Village of East Dundee
PRESIDENT AND BOARD OF TRUSTEES
Committee of the Whole
Monday, November 14, 2016
06:30 PM

SUBJECT: River Haven Development – Detention Pond Assessment

Subject: River Haven Subdivision
Punchlist for Final Acceptance
Job No.: ED-1900

BORING LOCATION PLAN RIVER HAVEN DEVELOPMENT DUNDEE AVENUE NORTH OF HIGGINS ROAD EAST DUNDEE, ILLINOIS

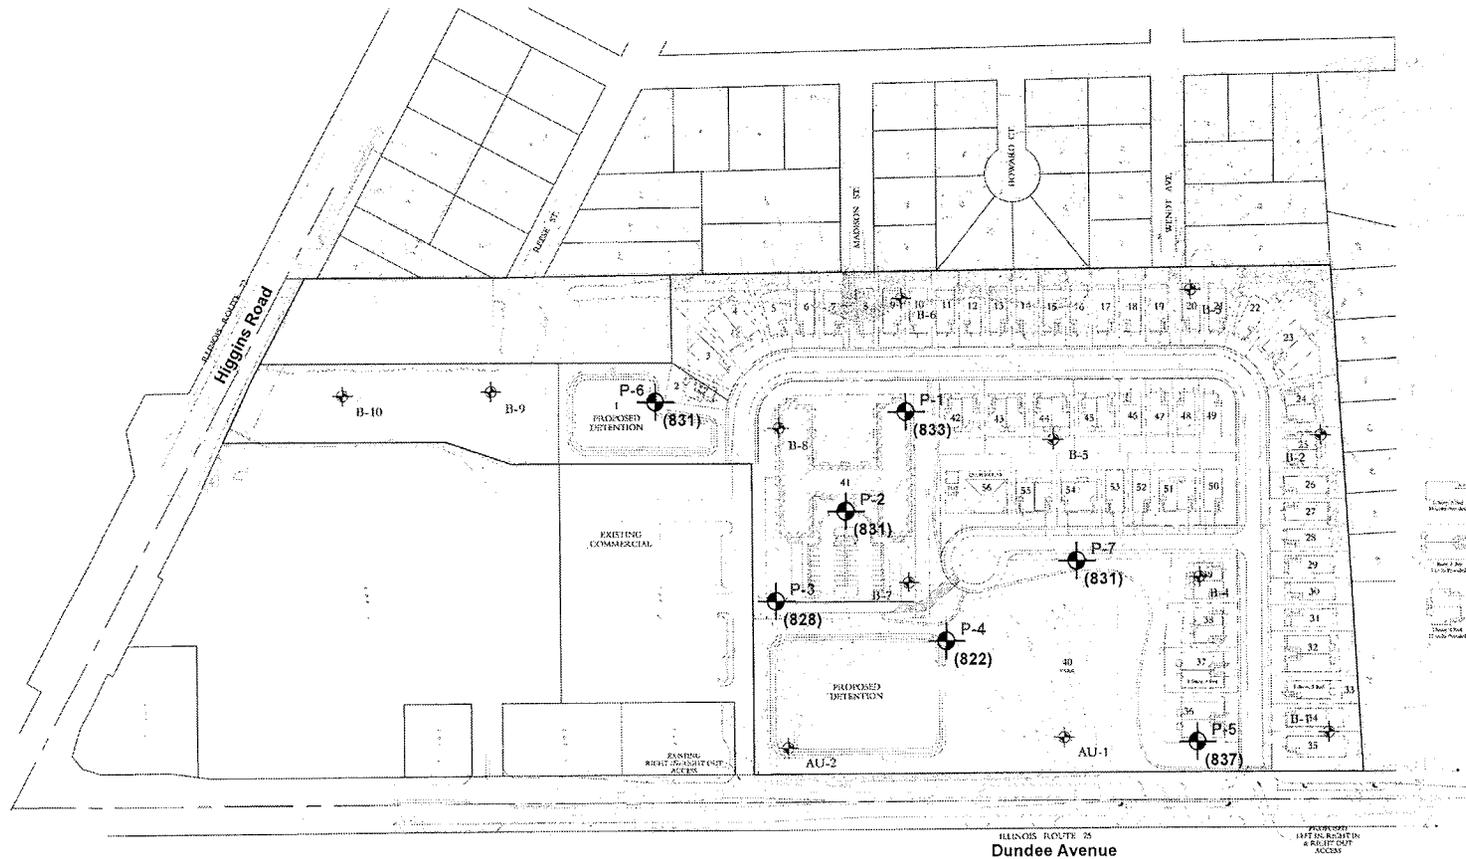
The original plan for both of the detention facilities was to be a dry bottom pond with French drains to promote infiltration into the existing sand/gravel layer. Soil Boring No. 4 from the original boring log shows that the gravelly sand layer runs approximately from 814.5 elevation down to 802. The gravelly sand layer may continue but the boring log stops at this elevation. The bottom of both detention ponds were set at an elevation of 816 with trench French drains proposed down to “a depth necessary to reach in situ gravel/sand layer”. The secondary outlet for the ponds is thru a storm sewer that has a release elevation of 820.21. Since the gravity release is approximately 4’ higher than the bottom of the pond, infiltration is required to keep the ponds dry.

The pond should be filled in with 3” stone up to the 815.5 elevation, geo-filter fabric placed on top of the stone and restore the area with 6”of topsoil and seed with a deep rooted vegetation seed mix. Before the stone is placed, the surface should be stripped in a few areas to expose the virgin gravelly soils to maintain the hydraulic connection.
